☐ REVIEWED WITHOUT CHANGES
☒ REVIEWED AS NOTED ~~HERE~~
☐ REQUIRES RESUBMISSION

CLIENT	ZANCOR HOMES
PROJECT/LOCATION	KING CITY KING CITY, ONTARIO
DRAWING	SITE GRADING PLAN

DRAWN BY	NC	SCALE	1:250	PROJECT NO.	09011	LOT NUMBER	28
----------	----	-------	-------	-------------	-------	------------	----

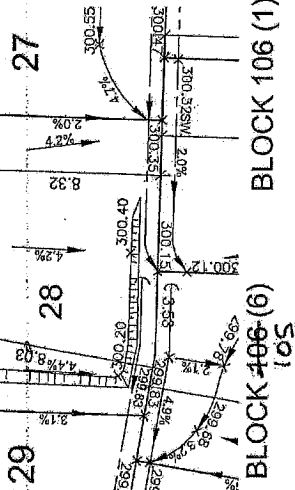
REVIEWED AS NOTED
ZONING BY LAW 74-53 AS AMENDED

- Builder to verify storm and sanitary service lateral elevations prior to pouring footings
- Extend footings at front to ensure 1.25M cover (Min)
- Garage footings to extend to original ground or as directed by soils engineer.
